RE: **House of Life Ministries**  
**Quaker Heights Rd NW**  
**Conceptual Grading Plan Stamp Date 1/20/20**  
**Drainage Report Stamp Date: 1/20/20**  
**Hydrology File: F11D020**

## DRAINAGE AND TRANSPORTATION INFORMATION SHEET (REV 6/2018)

RE: House of Life Ministries (F-11D020)

RE: **House of Life Ministries**  
**Quaker Heights Rd NW**  
**Conceptual Grading Plan Stamp Date 1/2/20**  
**Drainage Report Stamp Date: 1/2/20**  
**Hydrology File: F11D020**

ENGINEER'S SEAL	Title: House of Life Ministries Quaker Heights Pl. NW	DRAWN BY
	CONCEPTUAL GRADING AND DRAINAGE PLAN	DATE
	RHD Engineering, LLC 4305 Purple Sage Ave. NW ALBUQUERQUE, NM 87120 (505) 288-1621	SHEET # Appendix B
Richard Dourte P.E. #10854	1-20-20	JOB #

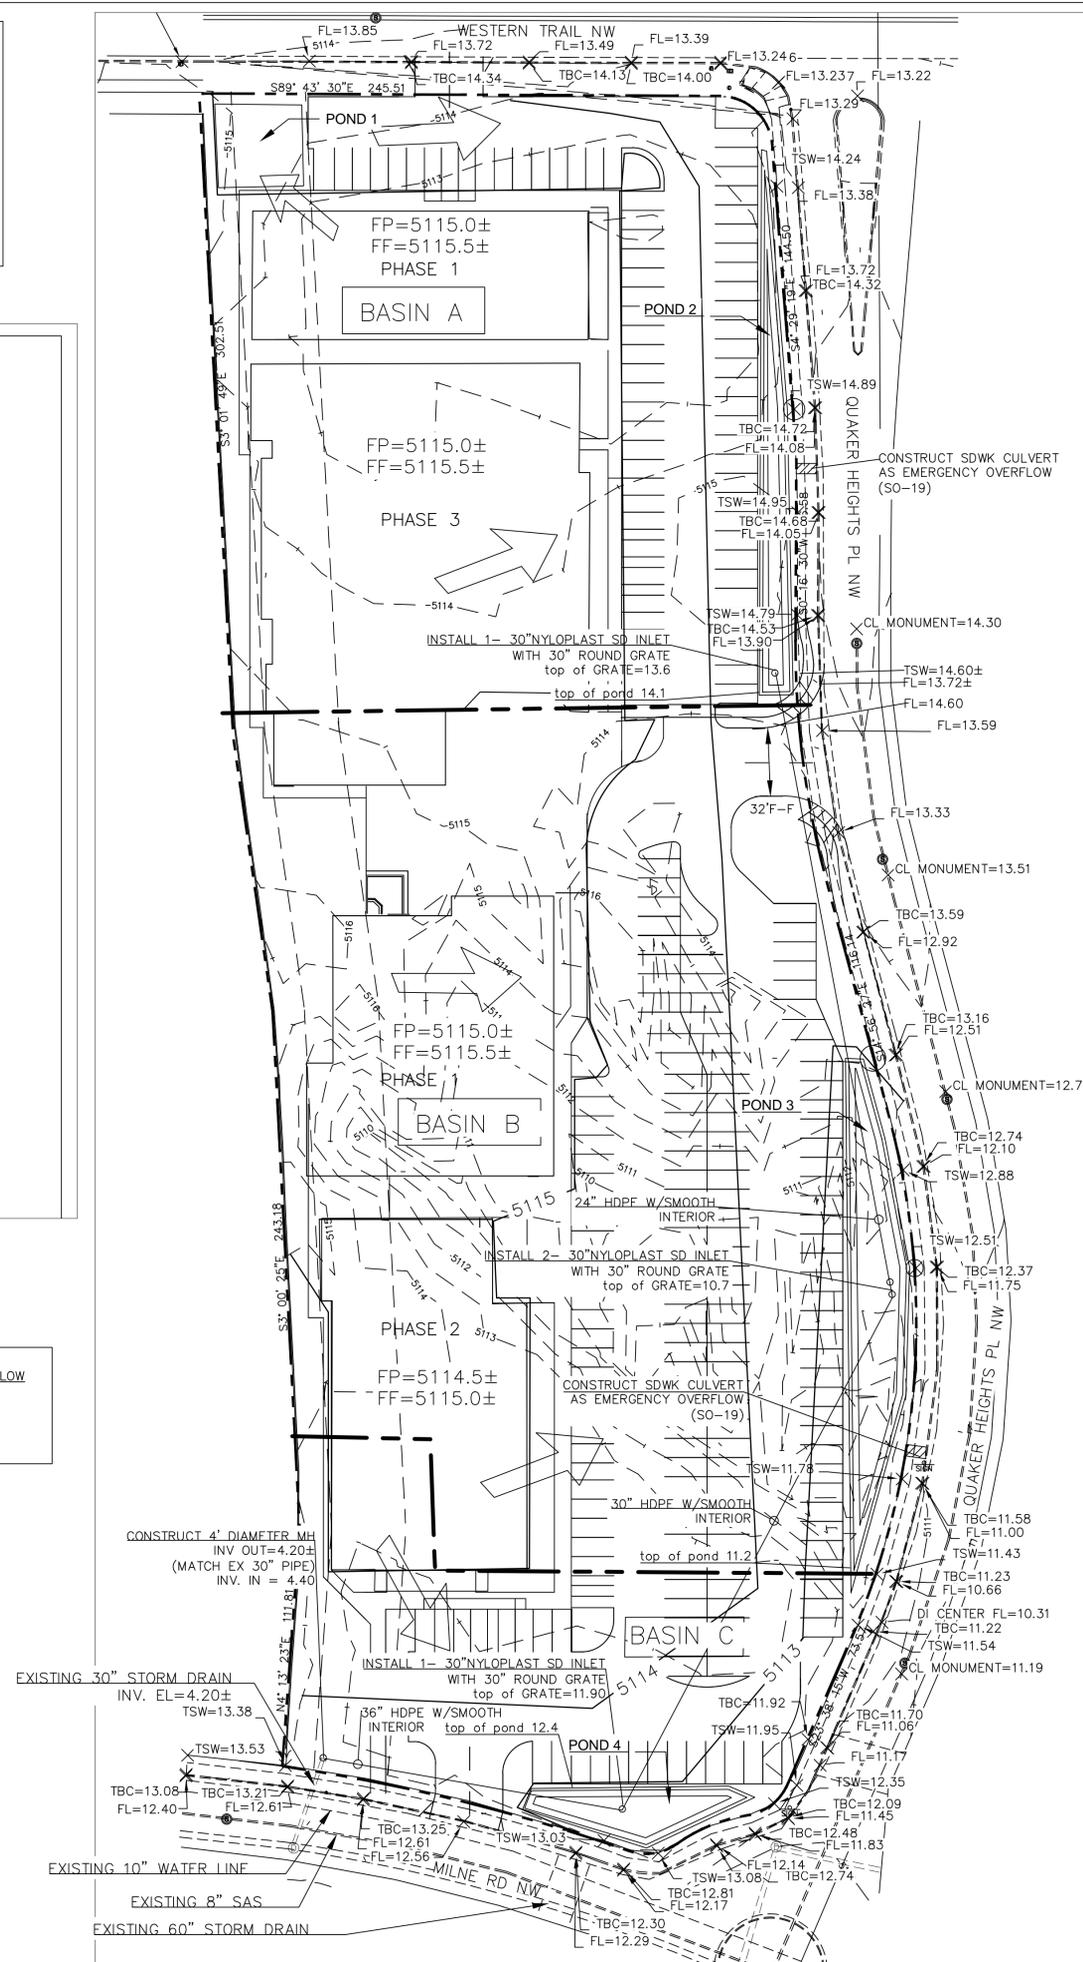
1. Will the sidewalk culvert be built by SO-19 or Work Order? Please label/provide notes as appropriate.
2. Provide proposed grading, finished floors, and spot elevations throughout the site.
3. The site must discharge in accordance with the approved master plan. Accounting for pond routing and stormwater quality volume will probably get within the allowable discharge and volume, but this analysis needs to be presented.
4. Please provide the SWQV calculations for each basin draining to each pond. The stormwater quality ponds need to be sized for the areas draining to them.
5. Please number the ponds and include a label on each with the SWQV and elevation, the 100-year volume and elevation, and the peak 100 year inflow and outflow.

1. The sidewalk culverts are to be constructed with SO-19. I have noted this on the plan adjacent to the construction note. The SO-19 notes have not been added at this time, and will need to be done when the grading and drainage plan for each phase is submitted.

2. Rough finish floor elevations have been added, along with contour lines to provide better clarity to this conceptual plan. Since a subsequent grading and drainage plan will need to be submitted for each phase, more detail will need to be provided at that time. A note on the plan has been added to indicate this.

3. As you correctly indicated, the pond routing did reduce the outflow of this site so that it does conform with the approved master plan for this area. The outflow rate is 19.28cfs and the permitted flows are 19.40cfs. The allowable discharge per the master plan is .807ac-ft and the calculated amount is .80ac-ft.

4. The requested calculations have been added to the plan.
5. The ponding information has been added to the plan in a table format.
